**Subject: Data Responses Set 1 (Responses to Data Requests 1 through 11)
GWF Hanford Combined Cycle Power Plant Project (01-EP-7)**

GWF Hanford Combined Cycle Power Plant

Data Responses Set 1

FIGURE DR9-1
ONE-LINE DIAGRAM FOR THE PG&E 115-KV
HANFORD SUBSTATION AFTER
INTERCONNECTION OF THE MODIFIED PROJECT
GWF HANFORD COMBINED-CYCLE POWER PLANT
HANFORD, CALIFORNIA

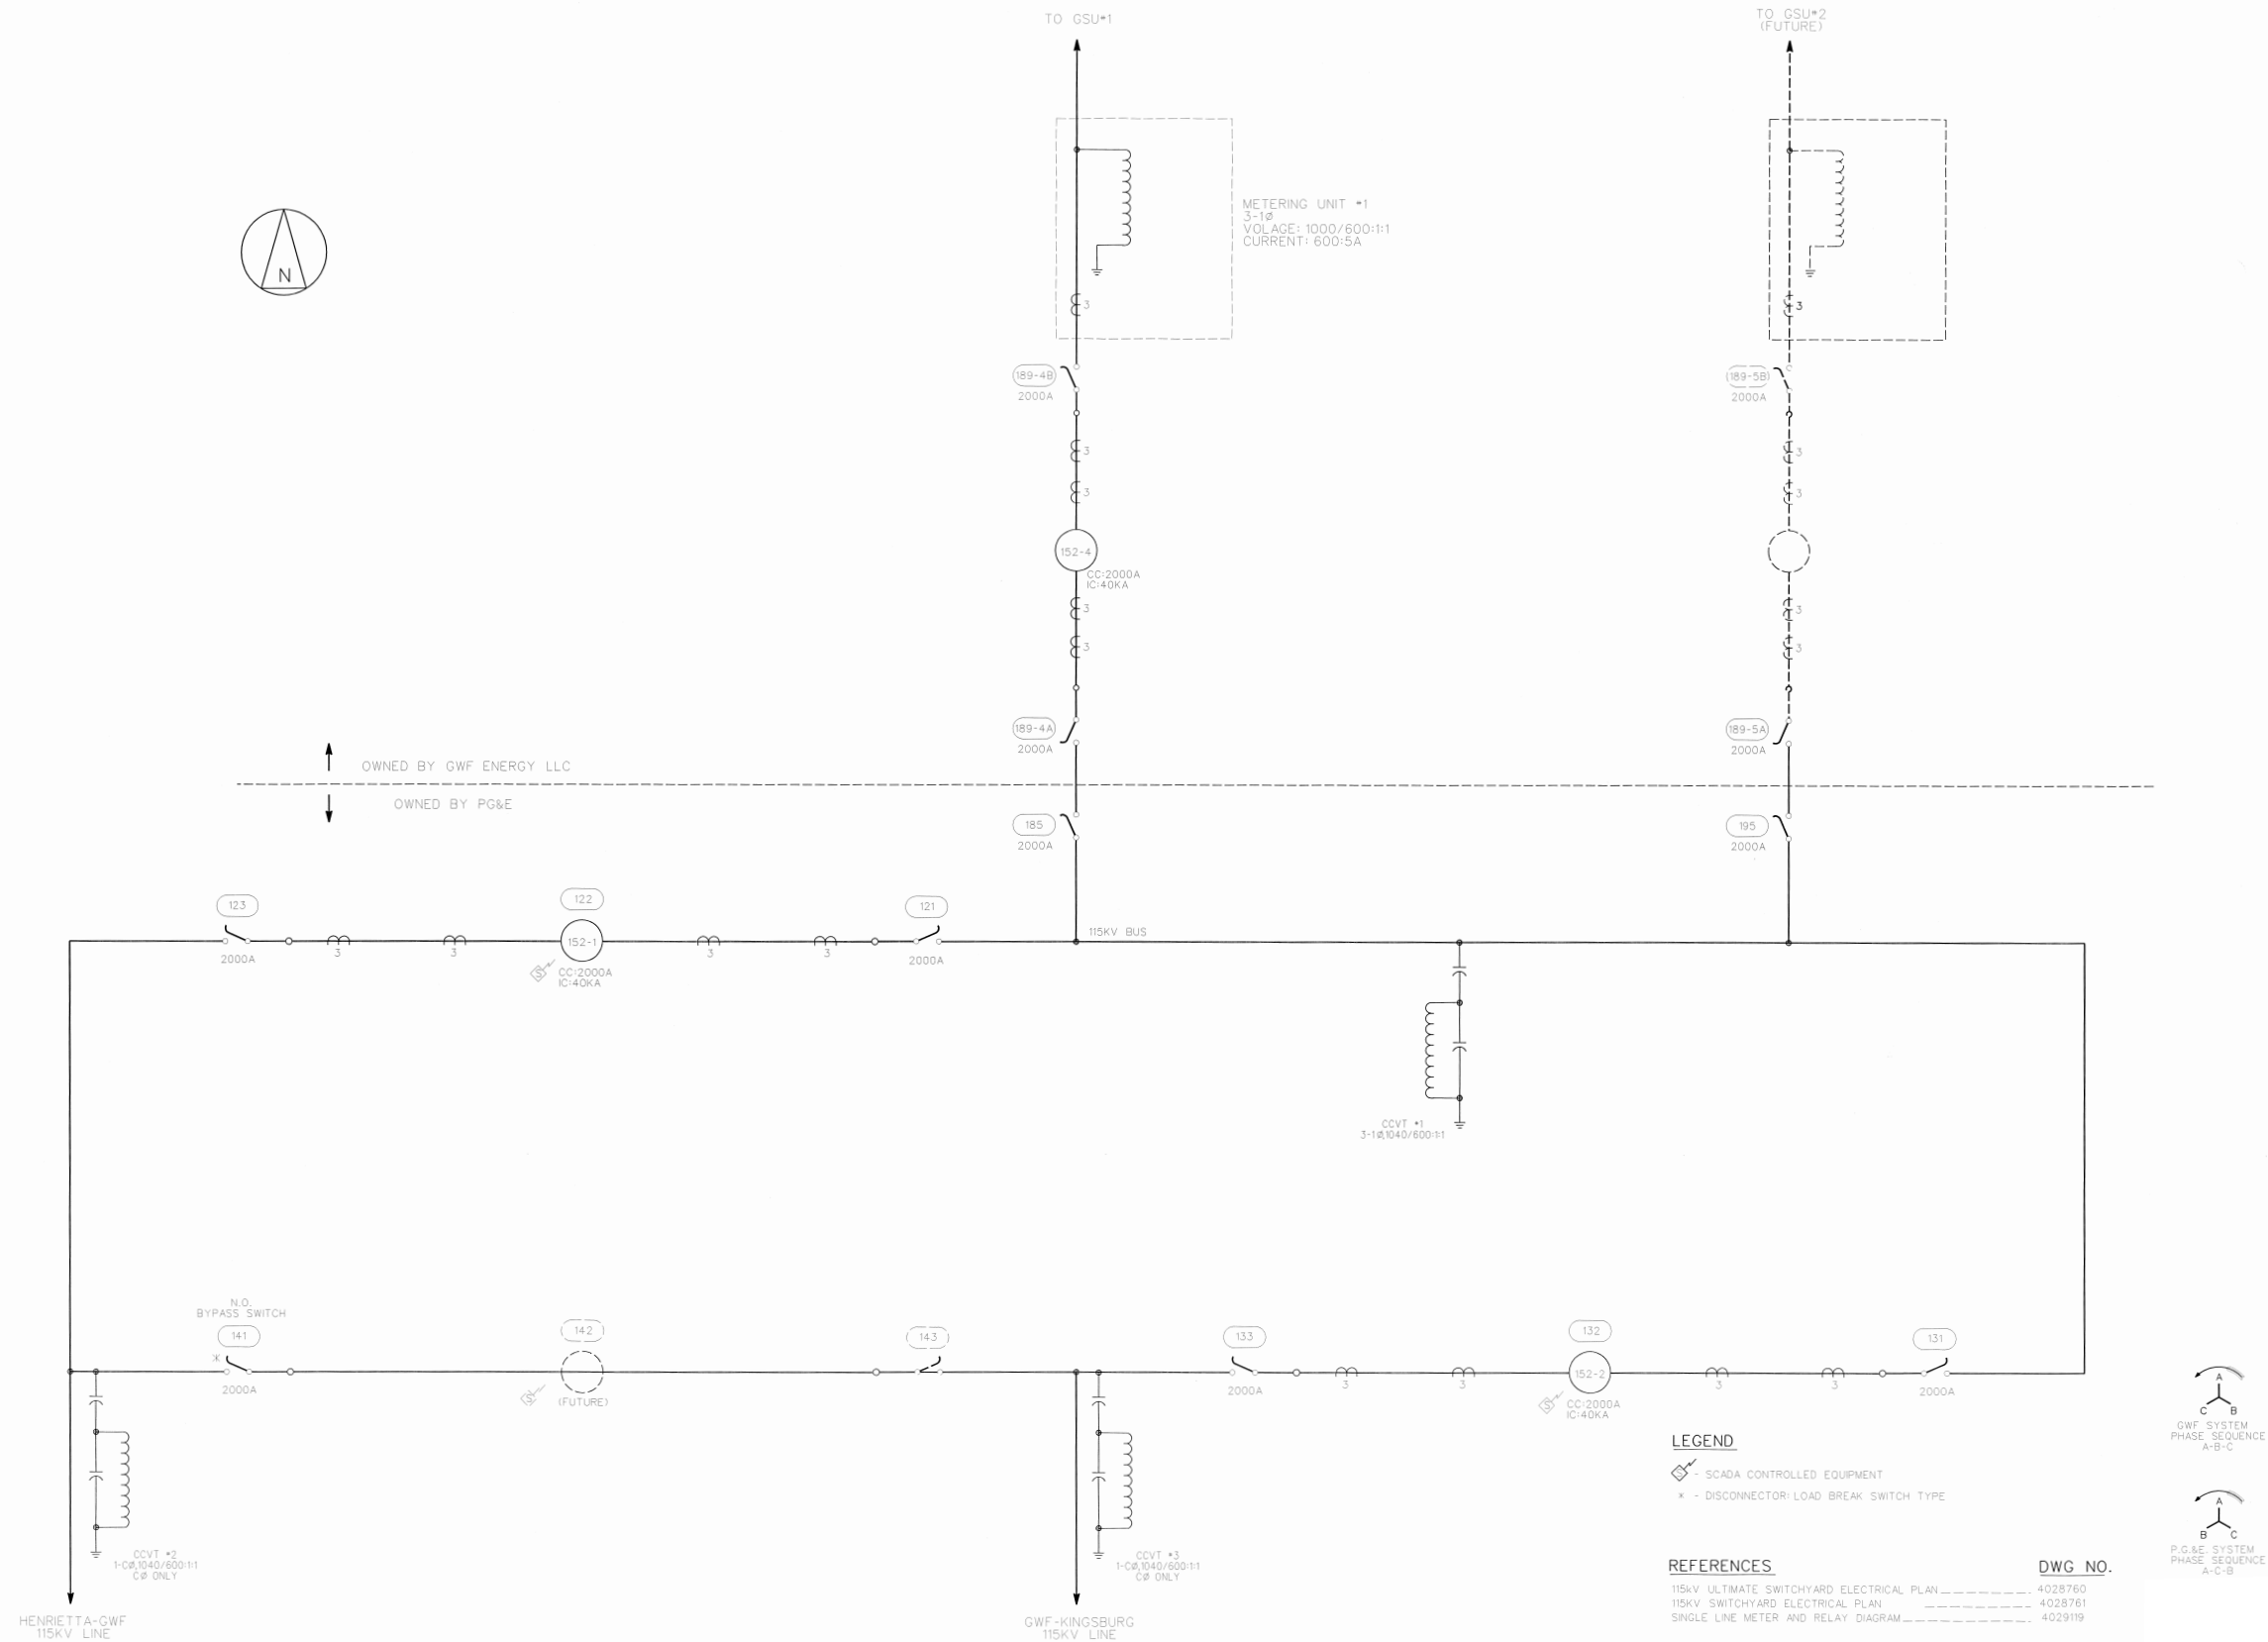
- 9. Provide a one-line diagram for the existing PG&E 115 kV Hanford Substation after interconnection of the modified project. Show the existing bay arrangement of the equipments with ratings such as breakers, disconnect switches and relays, etc. which are required to interconnect the project.

Response: Please refer to Figure DR9-1.

FIGURE DR10-1
DISTURBED AREAS
GWF HANFORD COMBINED-CYCLE POWER PLANT
HANFORD, CALIFORNIA

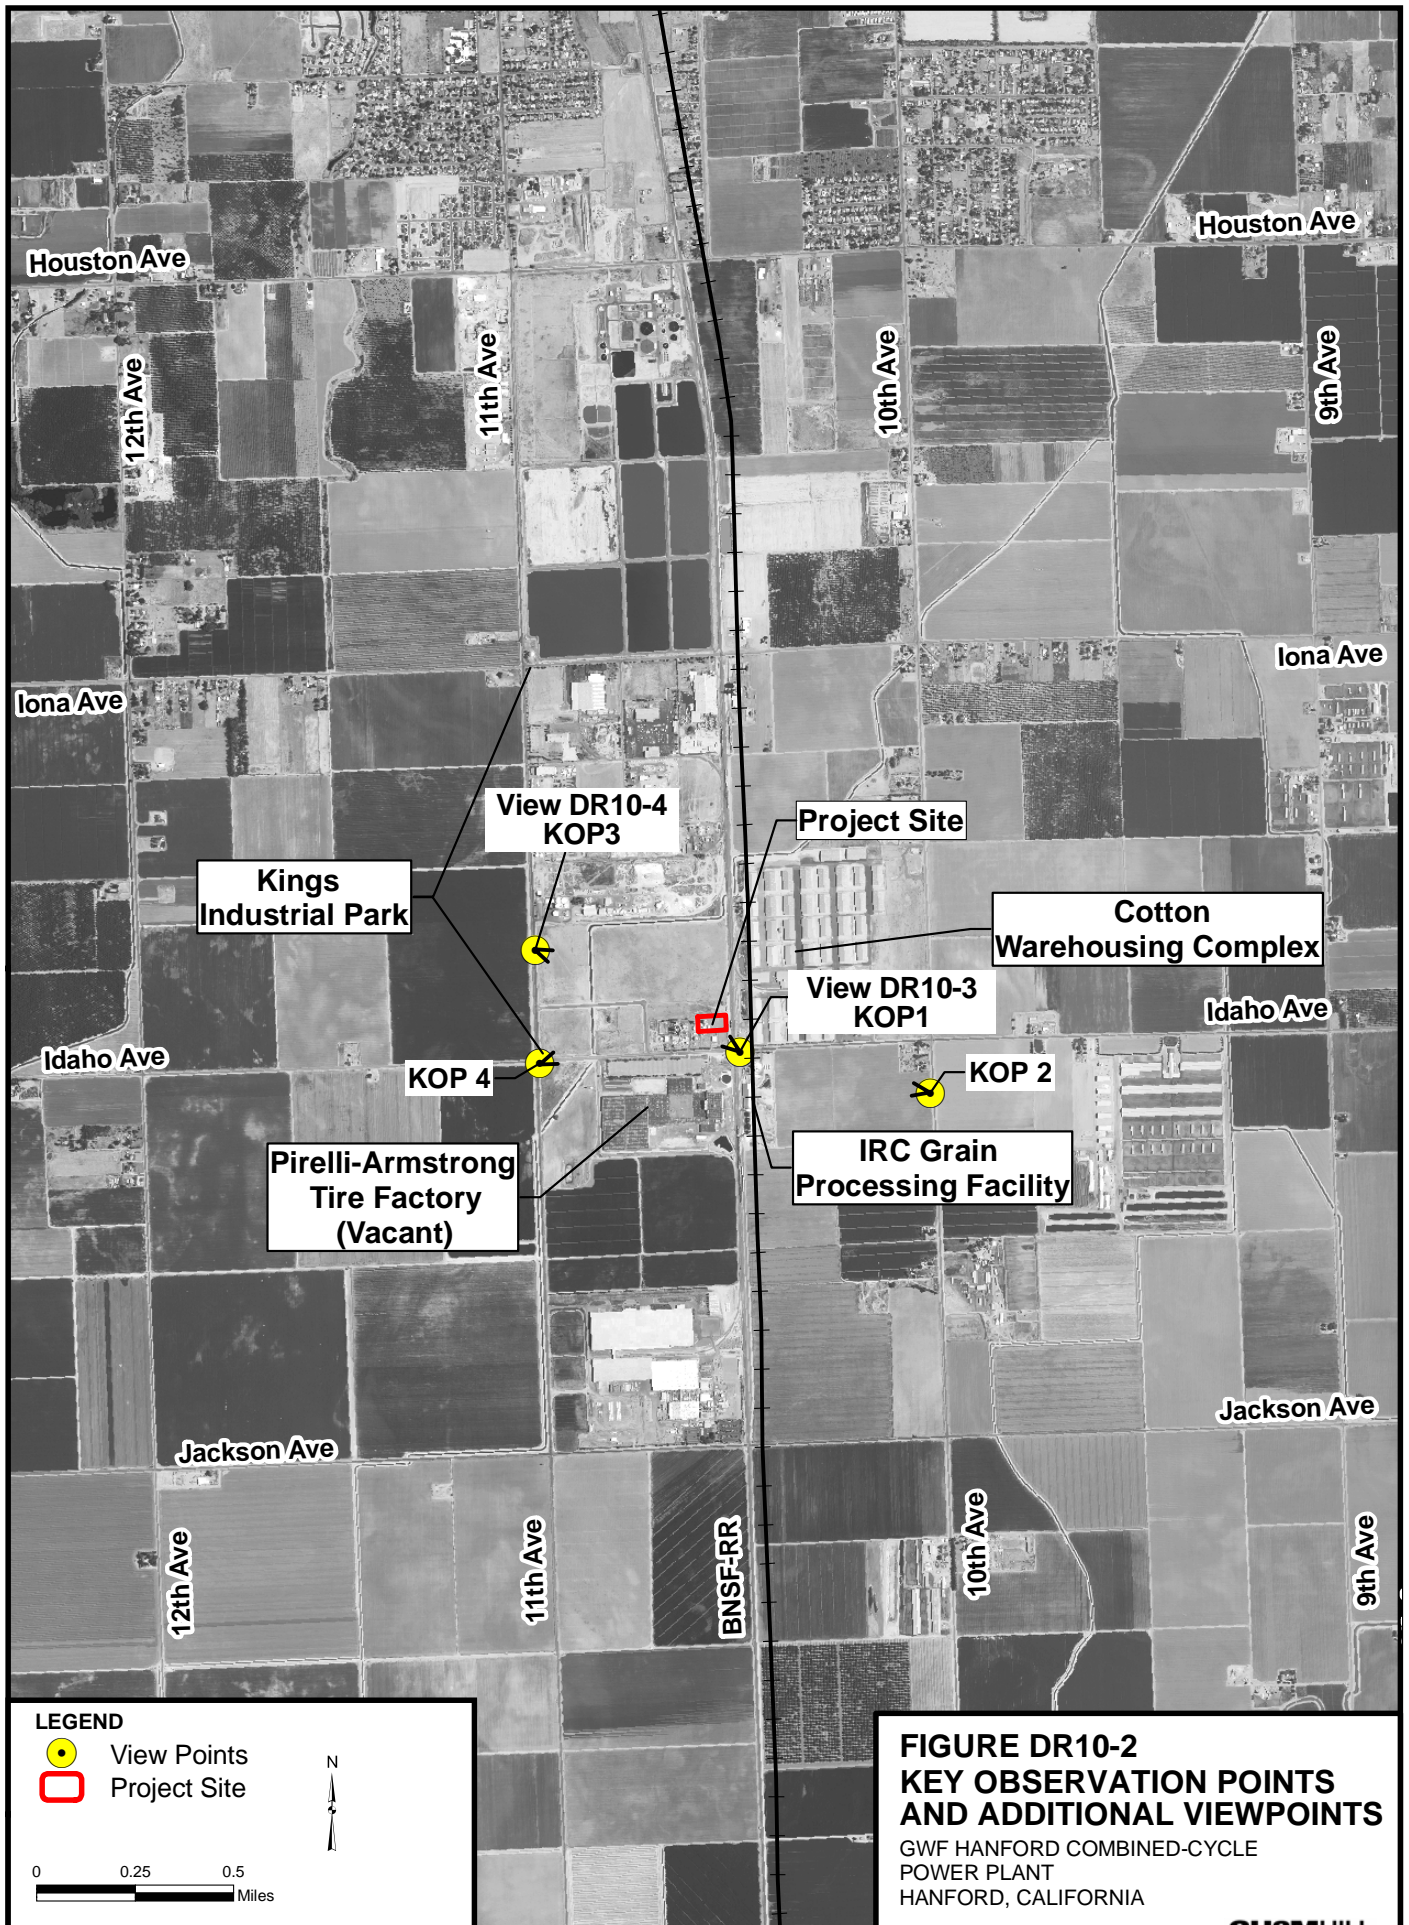
10. Please provide full-page color photographic reproductions of the existing site, including expansions. Please clearly identify all expansion areas as to their use; for example, construction, laydown, and parking.

Response: Consistent with Data Request 10 and following coordination with CEC staff, this response addresses CEC staff concerns related to the visibility of temporary construction and laydown areas for GWF Hanford. Figure DR10-1 shows the disturbed areas associated with GWF Hanford and specifically identifies the construction laydown and parking areas. Figure DR10-2 shows the locations of the key observation points (KOP) presented in the Visual Resources Section of the GWF Hanford License Amendment that are used to respond to this request. Figure DR10-3 shows the view from KOP-1 and is annotated to show the extent and location of the construction laydown and parking areas. Figure DR10-4 also shows the extent of the construction laydown and parking areas, as viewed from KOP-3, zoomed in at 200%.
